Duane Arnold Energy Center
Docket No. 50-331
Renewed Facility Operating License No. DPR-49

License Amendment Request (TSCR-183): Application to Revise Operating License and Technical Specifications for Permanently Defueled Condition

LICENSE AMENDMENT REQUEST (TSCR-183)

Figure 3.1.7-1 (page 1 of 1)
Sodium Pentaborate Solution Volume
Versus Concentration Requirements

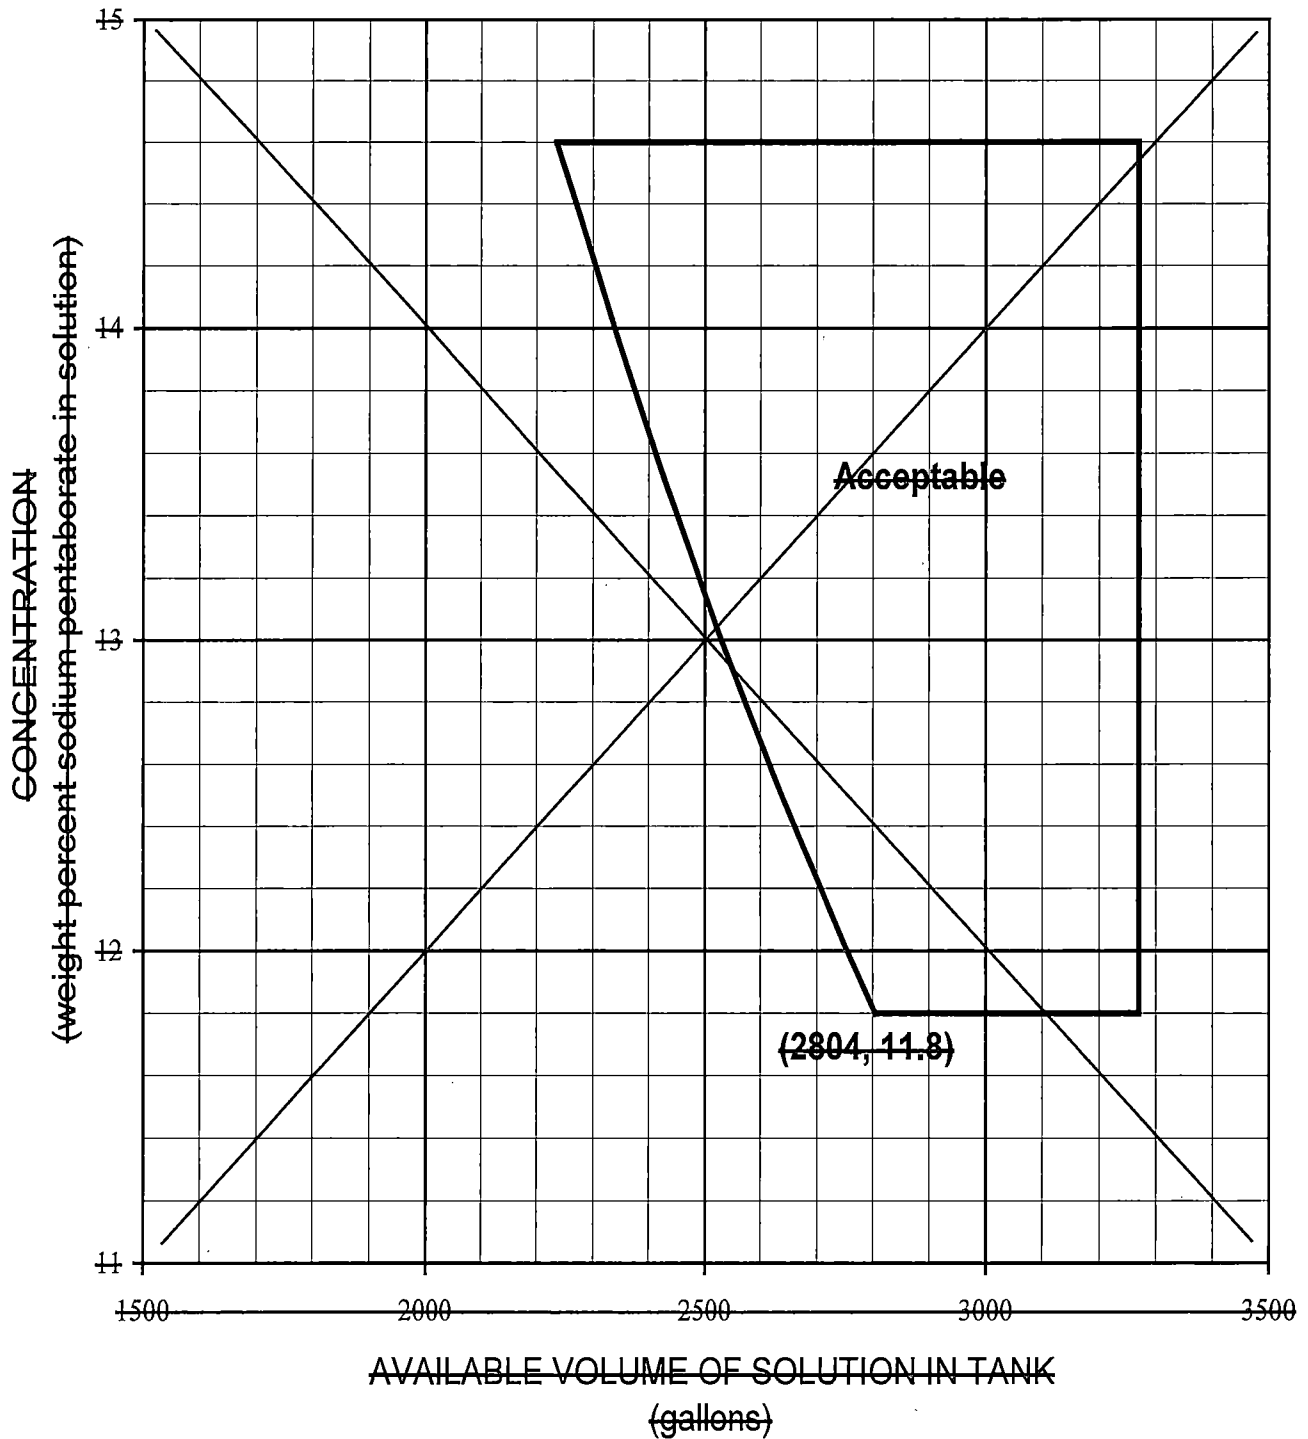
SURVEILLANCE		FREQUENCY
SR 3.1.7.1	Verify available volume of sodium pentaborate solution is within the limits of Figure 3.1.7-1.	In accordance with the Surveillance Frequency Control Program
SR 3.1.7.2	Verify temperature of sodium pentaborate solution is within the limits of Figure 3.1.7-2.	In accordance with the Surveillance Frequency Control Program
SR 3.1.7.3	Verify temperature of pump suction piping is within the limits of Figure 3.1.7-2.	In accordance with the Surveillance Frequency Control Program
SR 3.1.7.4	Verify continuity of explosive charge.	In accordance with the Surveillance Frequency Control Program
SR 3.1.7.5	Verify the concentration of boron in solution is within the limits of Figure 3.1.7-1.	In accordance with the Surveillance Frequency Control Program <u>AND</u> Once within 24 hours after water or boron is added to solution <u>AND</u> Once within 24 hours after solution temperature is restored within the limits of Figure 3.1.7-2

SURVEILLANCE		FREQUENCY
SR 3.1.7.6	Verify each pump develops a flow rate ≥ 26.2 gpm at a discharge pressure ≥ 1150 psig.	In accordance with the INSERVICE TESTING PROGRAM
SR 3.1.7.7	Verify flow through one SLC subsystem from pump into reactor pressure vessel.	In accordance with the Surveillance Frequency Control Program
SR 3.1.7.8	Verify all heat traced piping between storage tank and pump suction is unblocked.	In accordance with the Surveillance Frequency Control Program <u>AND</u> Once within 24 hours after solution temperature is restored within the limits of Figure 3.1.7-2
